UNITED STATES PATENT AND TRADEMARK OFFICE

APPLICATION NO.	FILING DATE	FIRST NAMED INVENTOR	ATTORNEY DOCKET NO.	CONFIRMATION NO.
10/507,360	01/28/2005	Steven Streatfield Gill	3174.00010	5703
7590	03/27/2006		EXAMINER POUS, NATALIE R	
Kenneth I Kohn Kohn & Associates Suite 410 30500 Northwestern Highway Farmington Hills, MI 48334			ART UNIT	PAPER NUMBER
			3731	
DATE MAILED: 03/27/2006

Office Action Summary	Application No. 10/507,360	Applicant(s) GILL, STEVEN STREATFIELD	
	Examiner Natalie Pous	Art Unit 3731

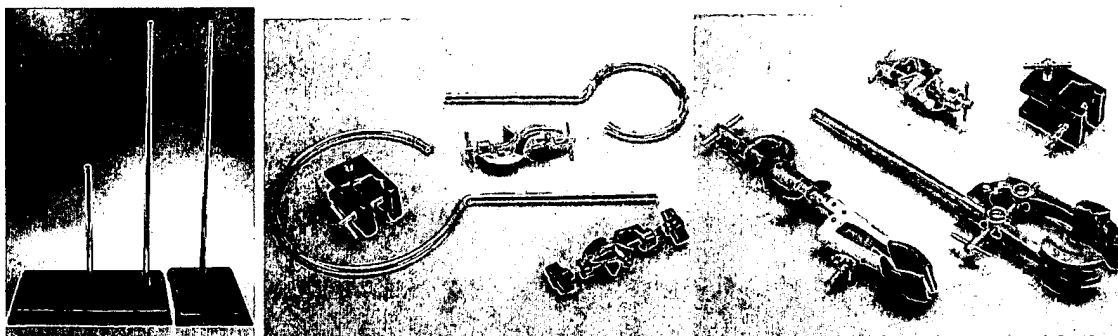
Regarding Claim 1, Warner teaches a stereoguide comprising first (16) and second (12) guide elements through which instruments are passed along an axis of insertion towards a target; characterized by a first clamp (38) having a clamping position on the axis between the guide elements and the target, or on the opposite side (16, 12) of the guide elements for clamping instruments passing through the guide elements (fig. 1).

Regarding claim 3, Warner teaches a stereoguide according to claim 1, wherein the or each clamp (38) is moveable away from its clamping position (it is noted that clamp (38) is a screw that untwists from portion (32) to unclamp).

Regarding Claim 4, Warner teaches a stereoguide according to claim 3, wherein the or each clamp is swivelable away from its clamping position (it is noted that screw head (38) "swivels" when twisted).

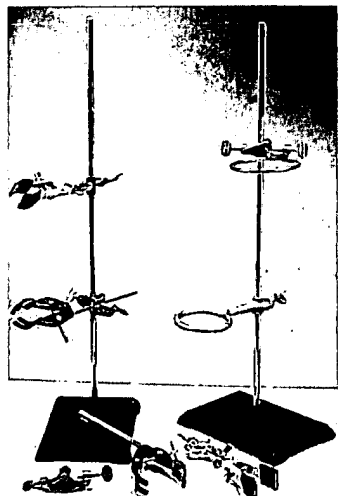
Claims 1-5 are rejected under 35 U.S.C. 102(a) as being anticipated by Indigo Instruments (<http://www.indigo.com/>). Indigo asserts that the combination of posts, guide members and clamps may be used for any experimental setup figure d) below,

simply illustrates an example of an experimental setup. Therefore, Indego teaches a device capable of use as a comprising first and second guide elements through which instruments are passed along an axis of insertion towards a target; characterized by a first clamp having a clamping position on the axis between the guide elements and the target, or on the opposite side of the guide elements for clamping instruments passing through the guide elements. Further comprising a second clamp having a clamping position on the axis of insertion and on the opposite side of the guide elements to the first clamp for clamping instruments passing through the guide elements wherein the or each clamp is moveable away from its clamping position. wherein the or each clamp is swivelable away from its clamping position, and wherein the second clamp is disposed between the guide elements and the target.
